ADMINISTRATIVE AMENDMENT

SUMMARY OF CHANGES

2430 LOUISIANA BLVD. NE
ALBUQUERQUE, NM 87110, USA
PROTOTYPE VERSION: GEN 2.5
REVISION DATE: 2020.02.11
ID PACKAGE- ENLIVEN DECOR
PACKAGE VERSION 2.5

PROJECT NO.
B4-176-1901

MASTER SITE PLAN

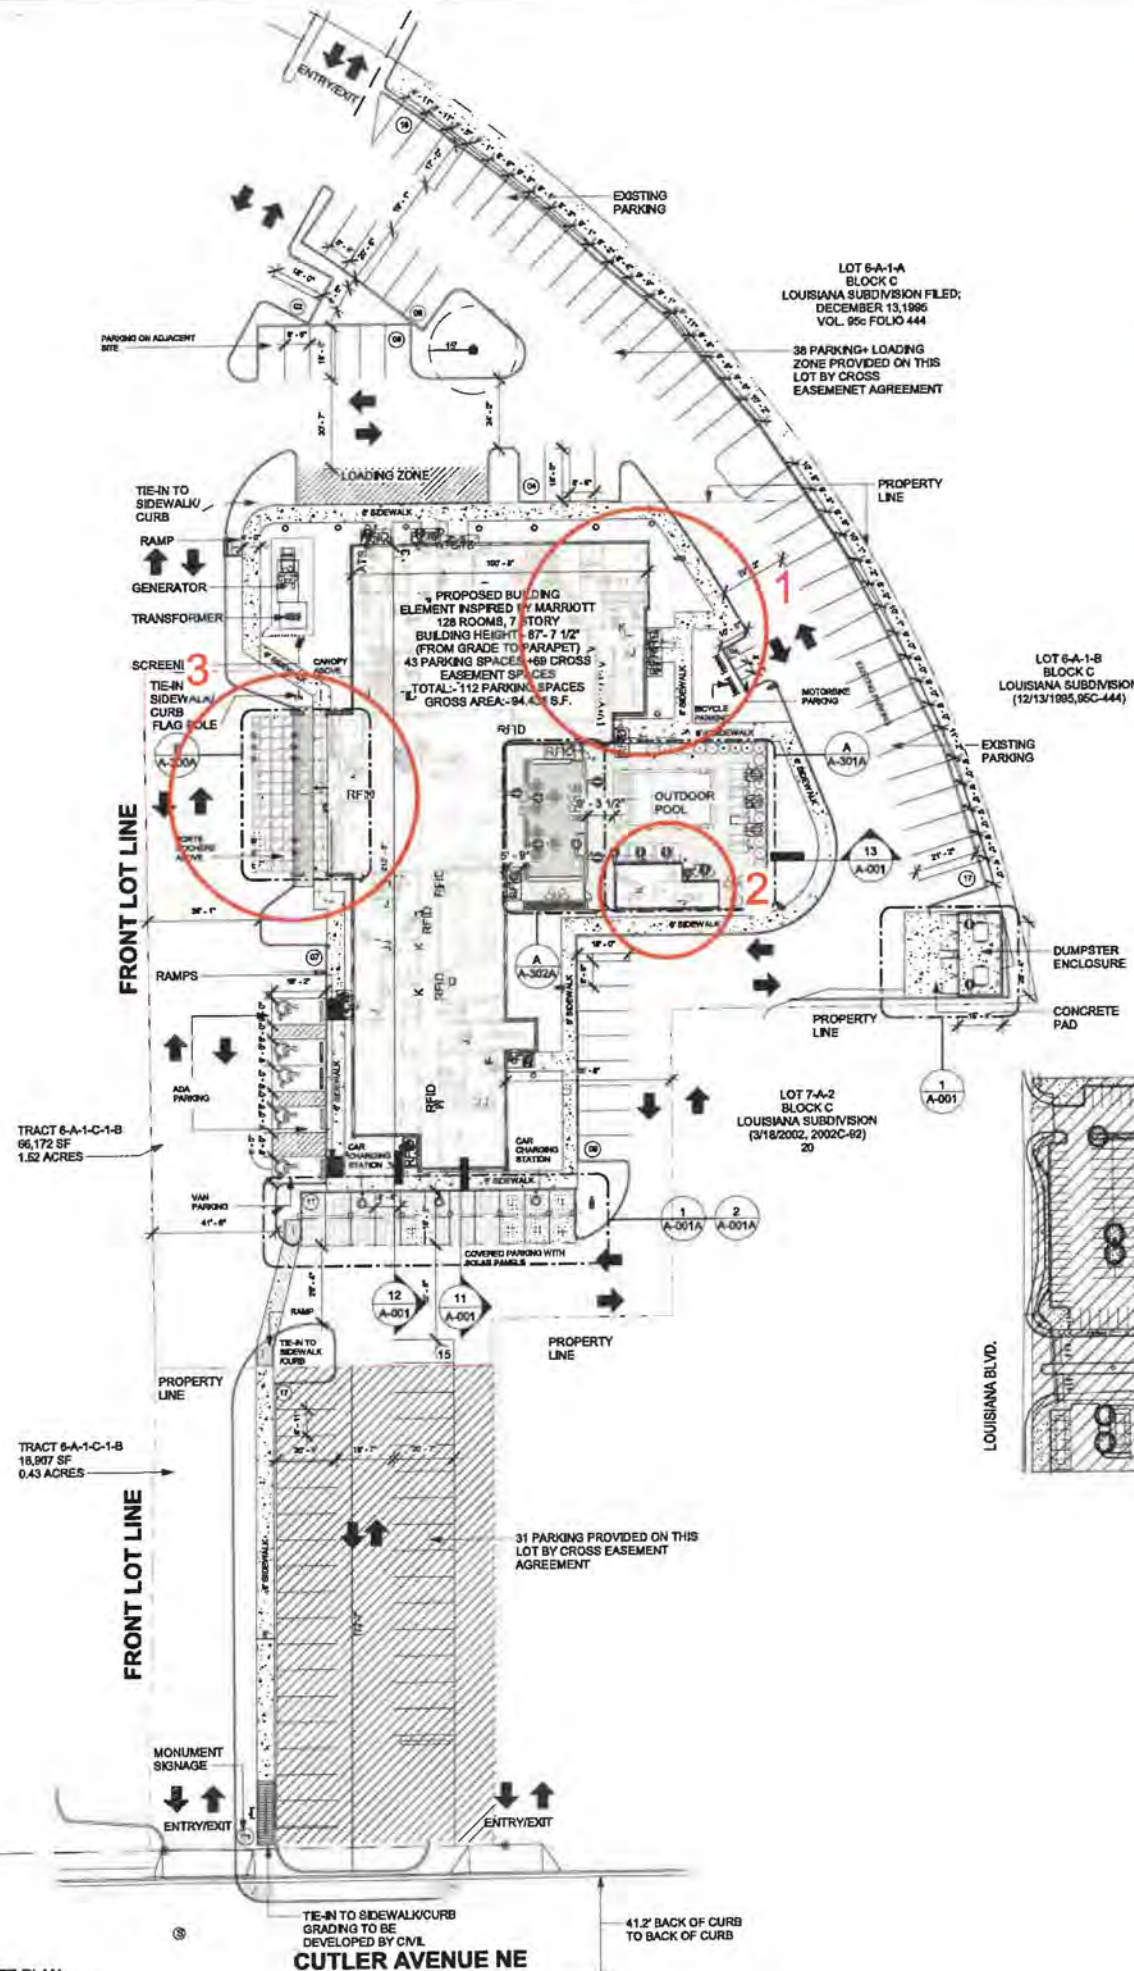
1. The building end has changed due to relocating guest rooms and room types.

2. The outdoor pool bathroom, shower and mechanical room have been relocated in order to provide more circulation around the pool.

3. The porte cochere canopy has been included to protect guests from the elements at the drop off.
